CORRIGENDUM - 1 TO TENDER SPECIFICATION BHEL PSSR SCT 1742 - DT: 23.06.2018

TENDER SPECIFICATION BHEL PSSR SCT 1742 - Road formation works up to WBM level inside plant area at BHEL 2X660MW Ennore SEZ STPP, Vayalur BR PO, Minjur Tamilnadu State

RCC ROAD DETAIL

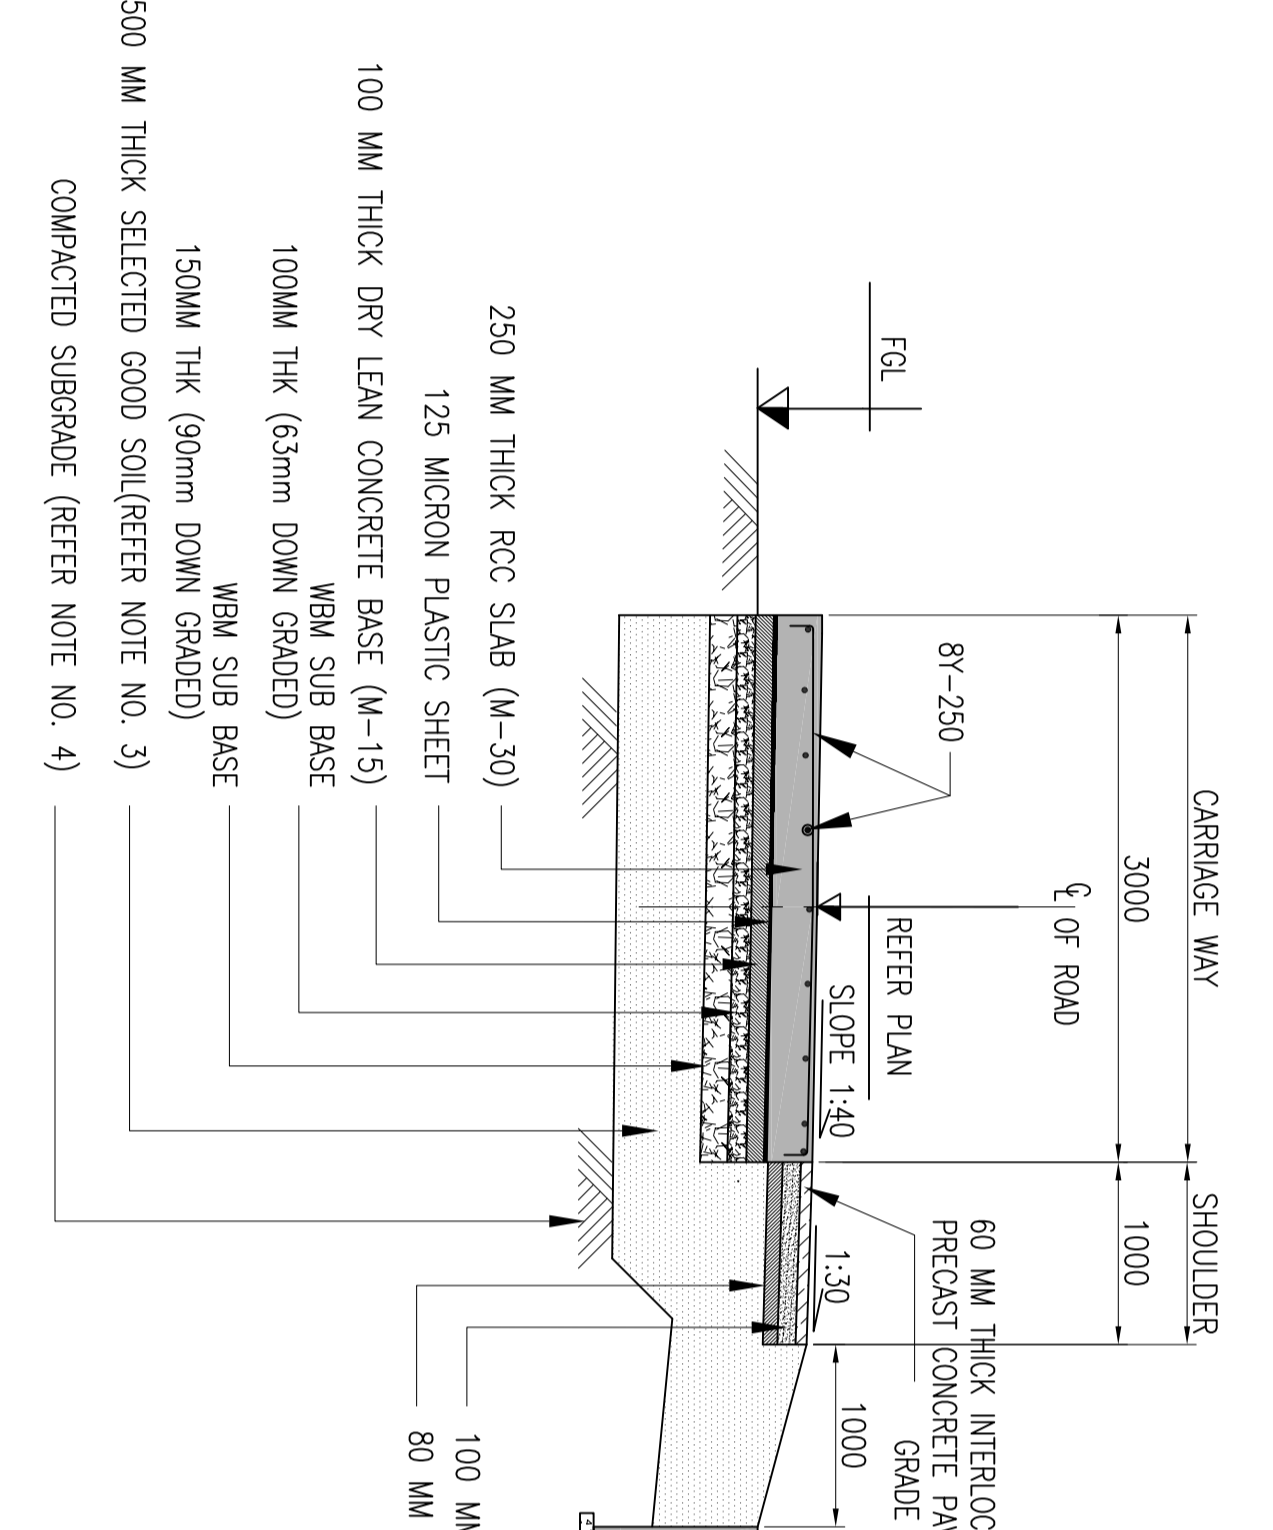
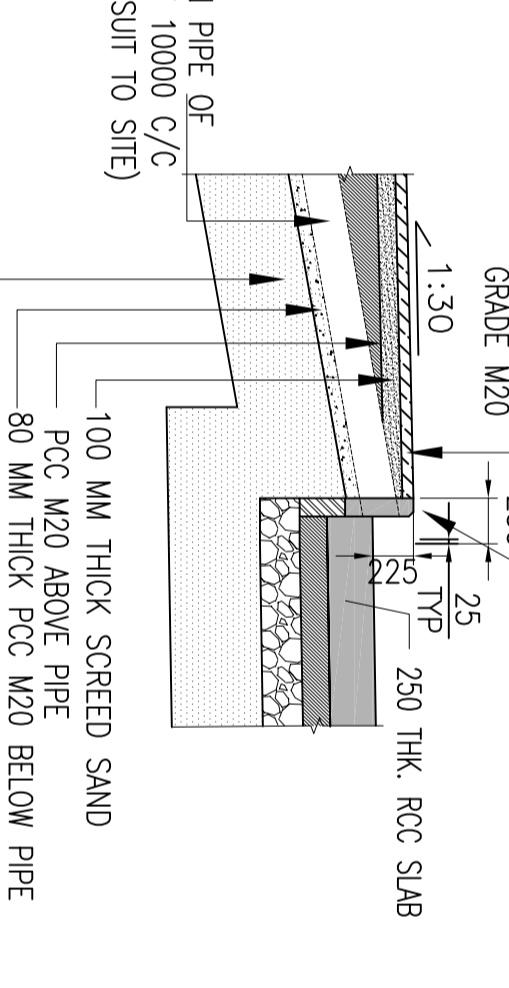
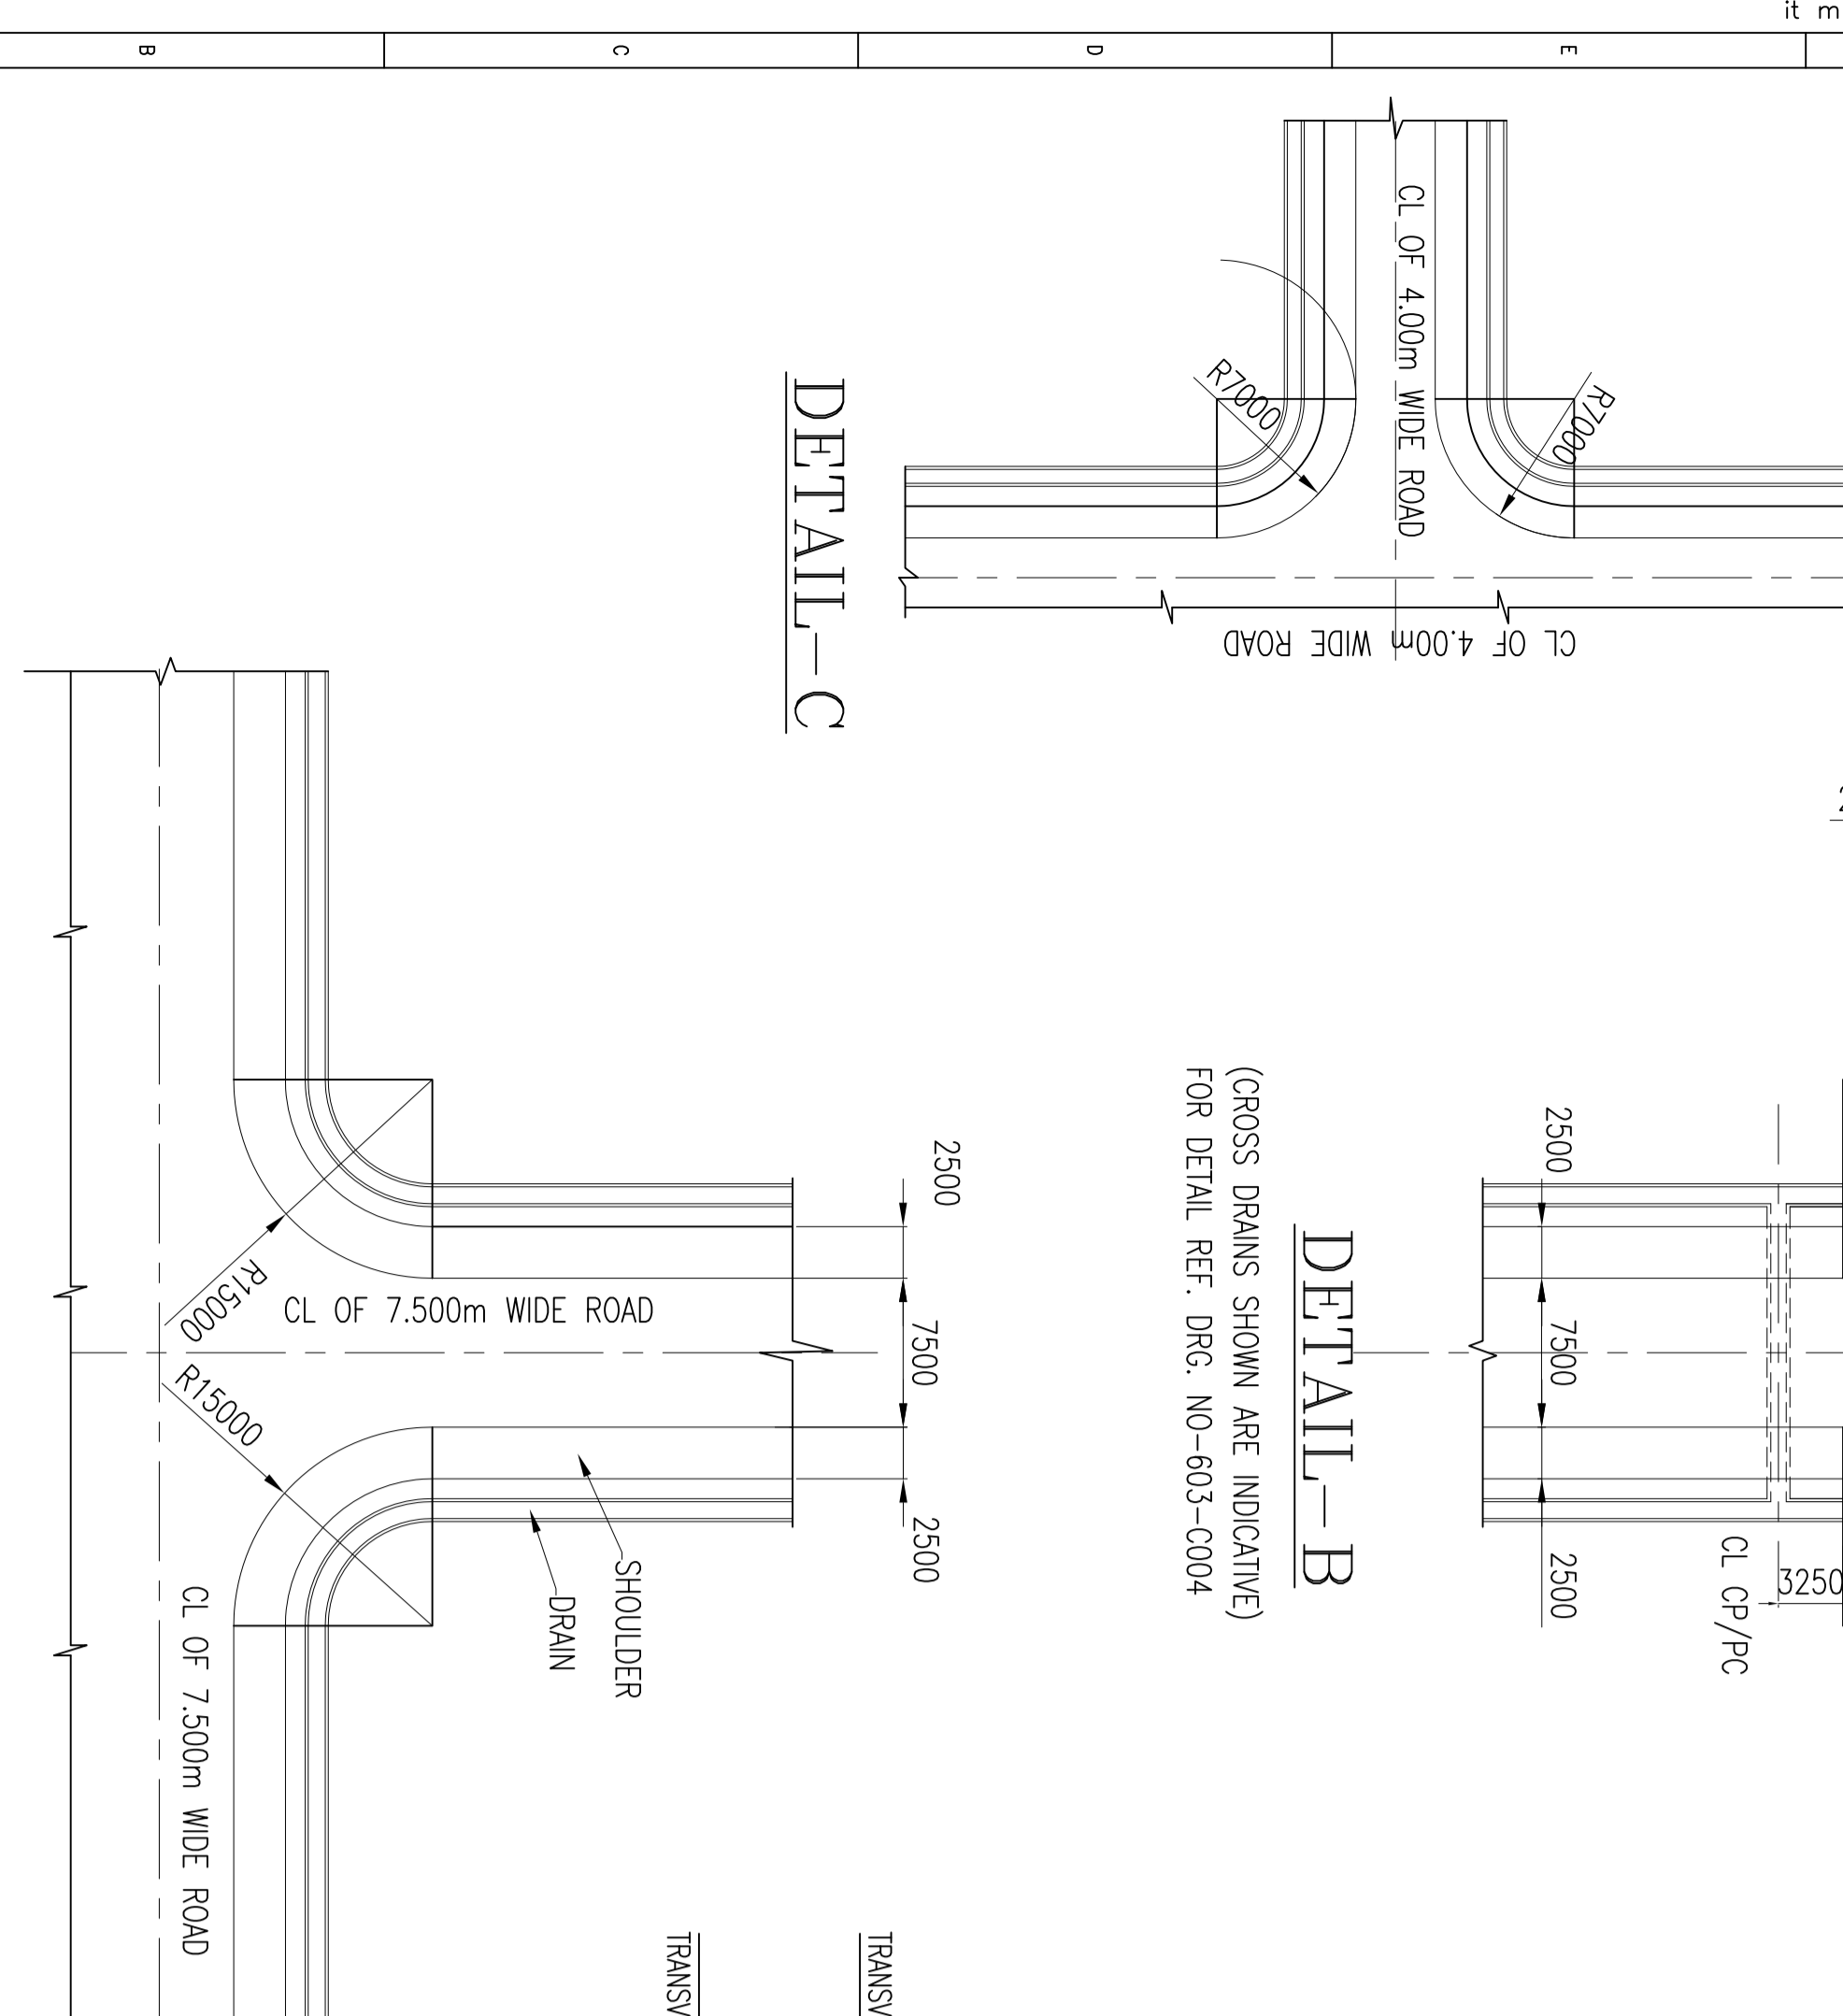
<u>Sl. No.</u>	<u>Bidder's Query</u>	<u>BHEL reply</u>
1	Section drawings for Road works shall please be provided.	Drawing (one page) of 'Plant Road cross section & details' for the said tender attached with this Corrigendum.
